ORIGINATION FORM

Proposed Revisions to a Standard Plans Index (Please provide all information – Incomplete forms will be returned)

Index Number: 455-130 Sheet Number (s): 1, 2 Index Title: 30" Square CFRP & SS Prestressed Concrete Pile

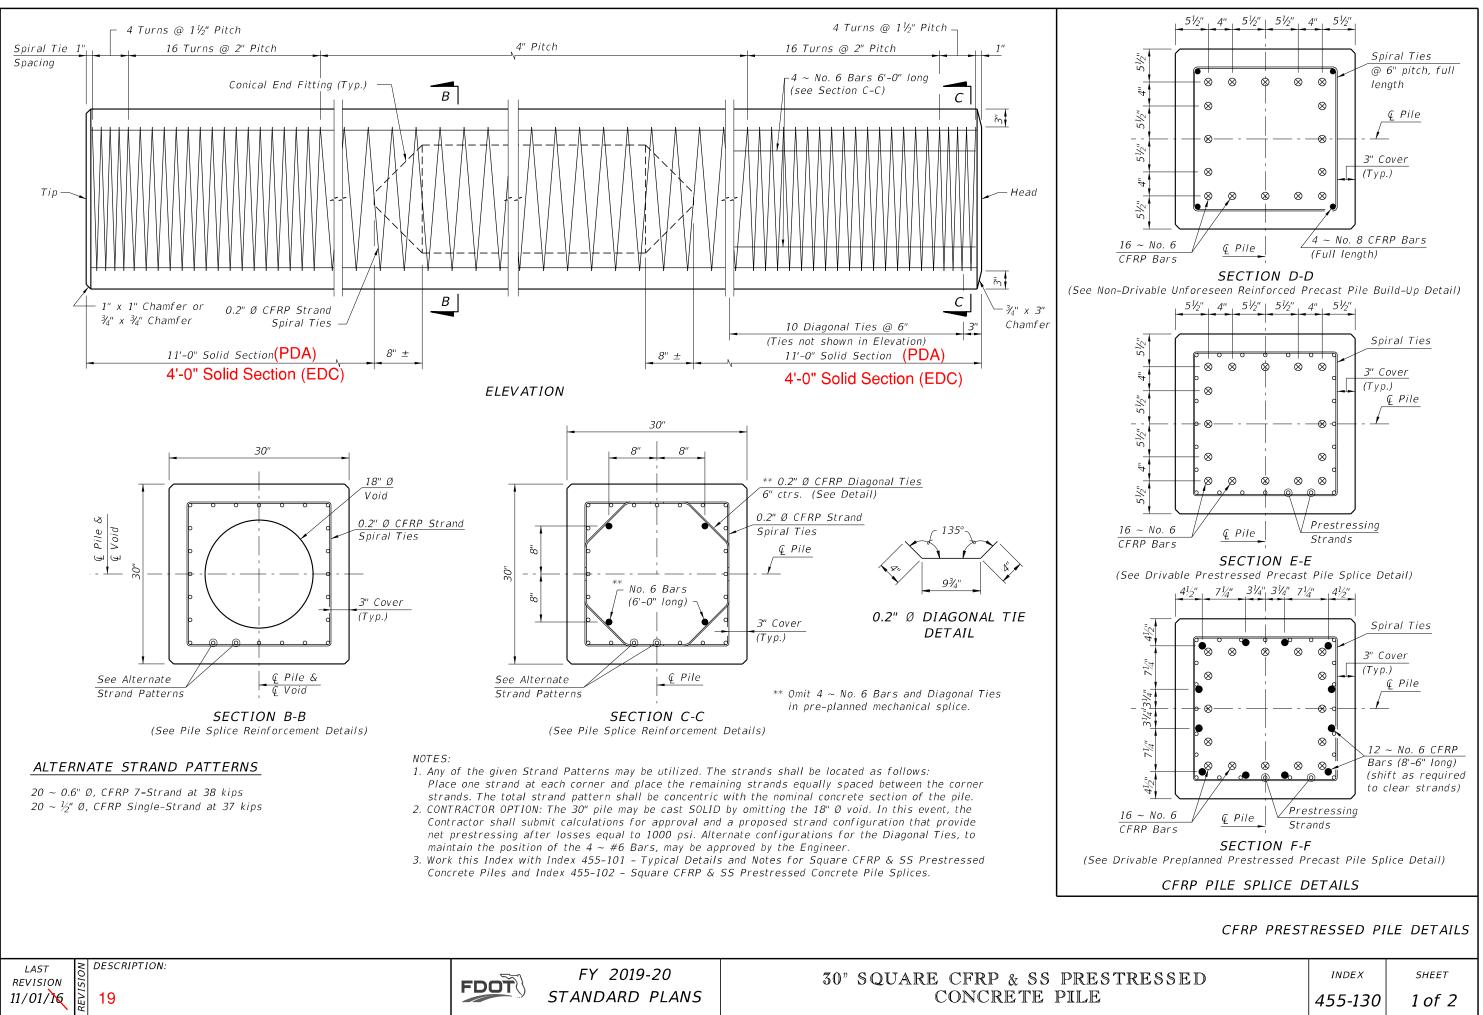
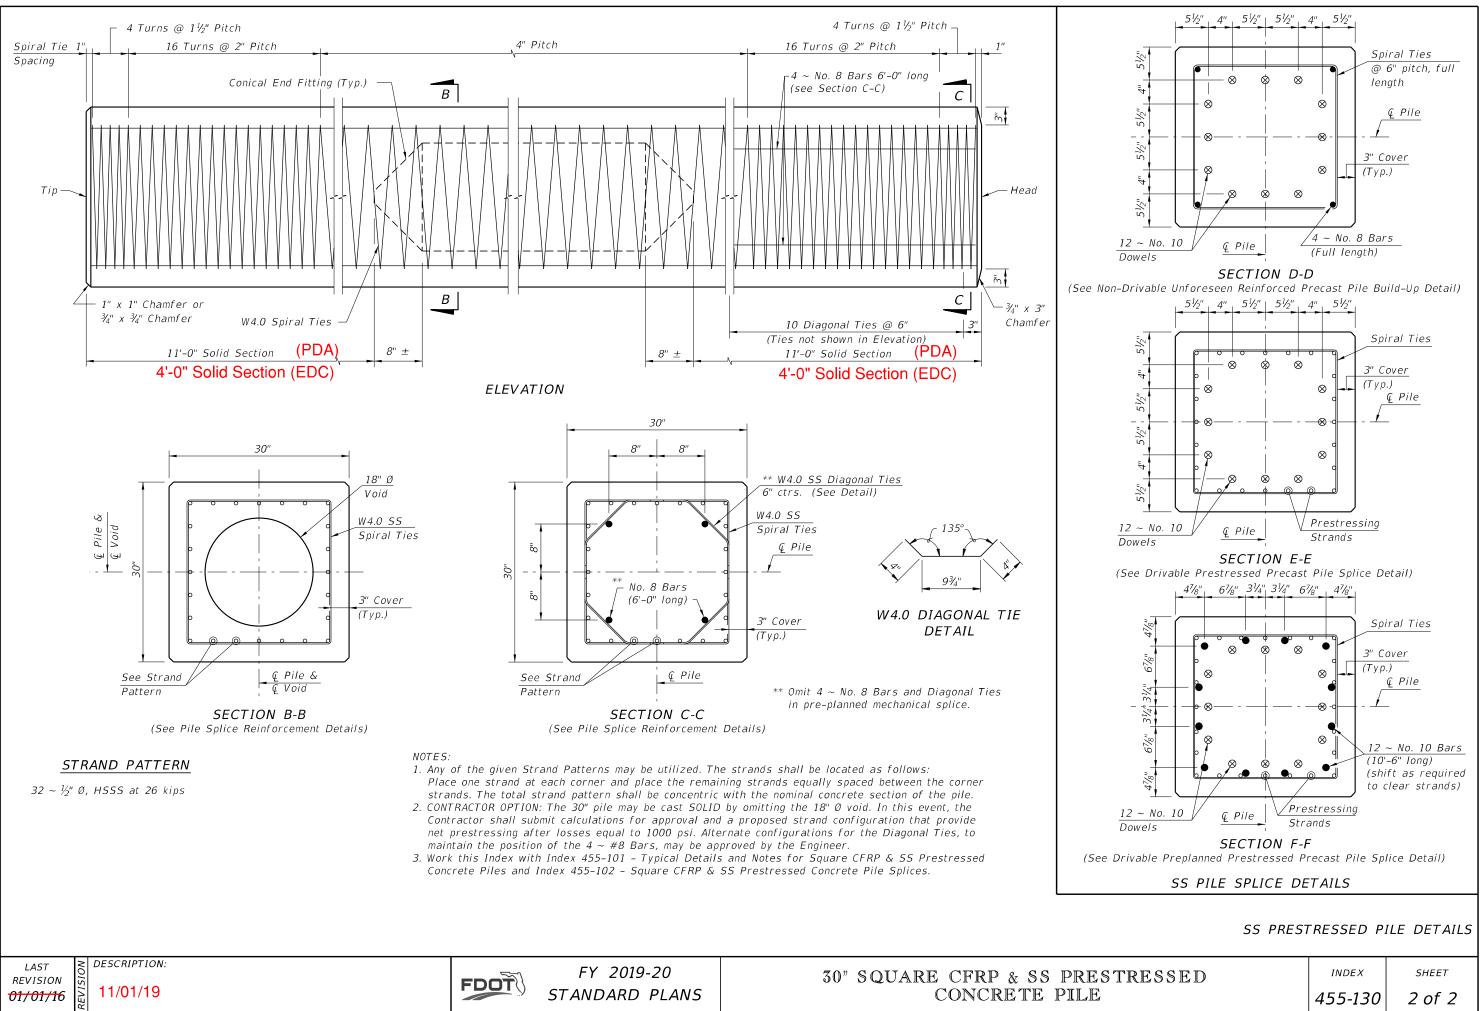
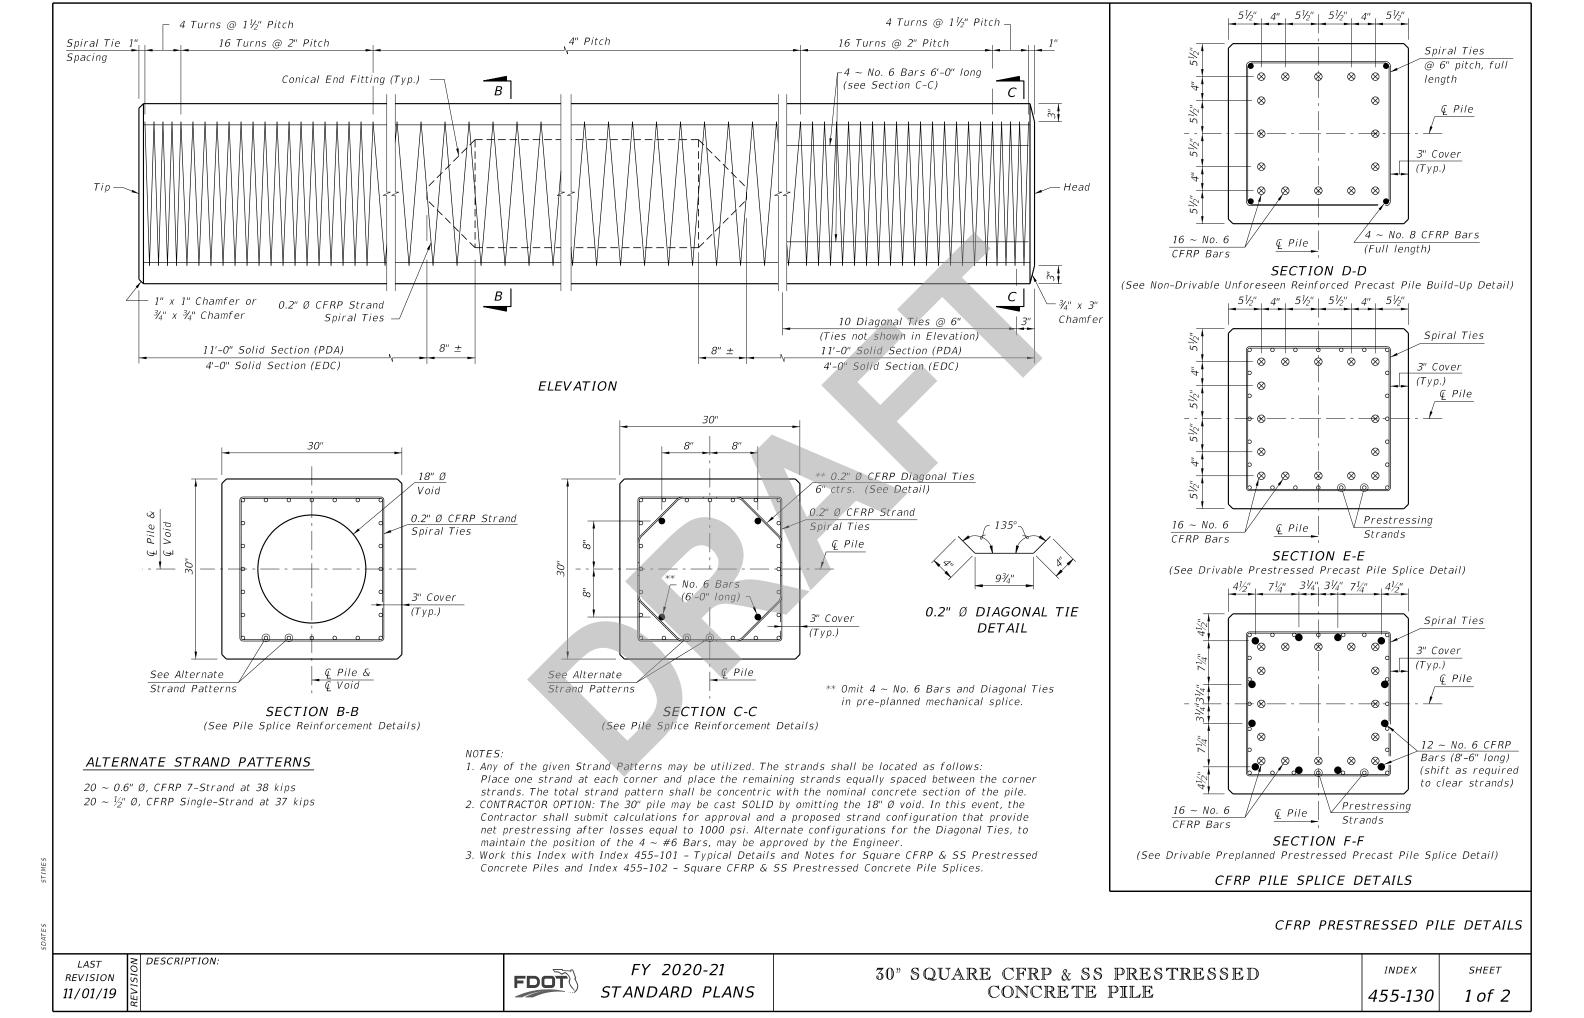
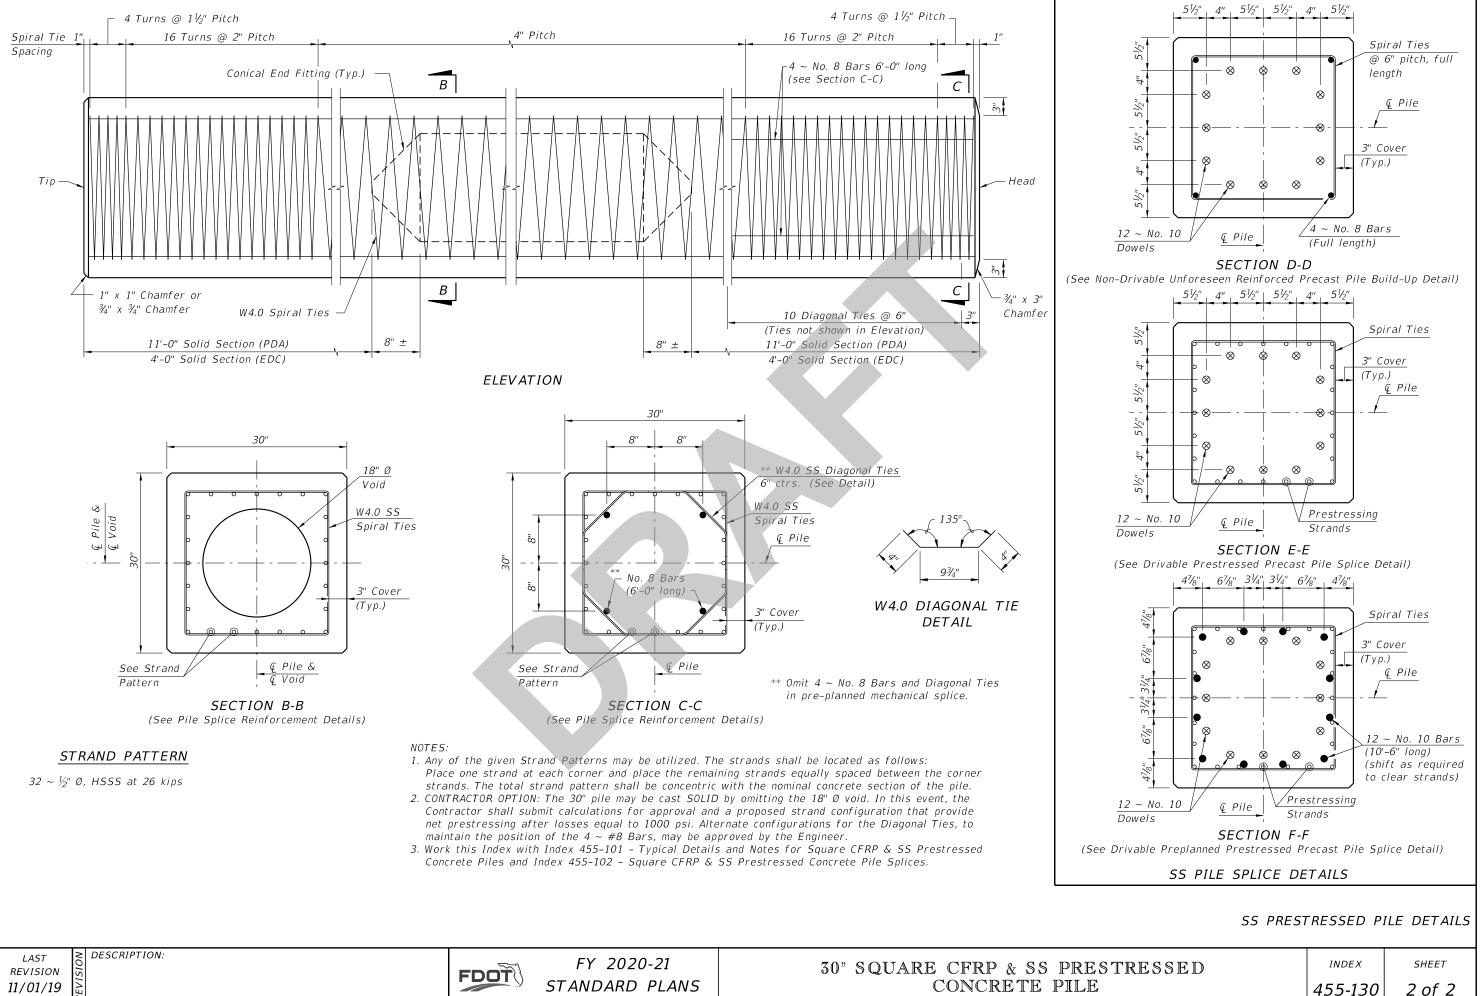
Added void length dimension for EDC

Double dimensioned void length for PDA & EDC
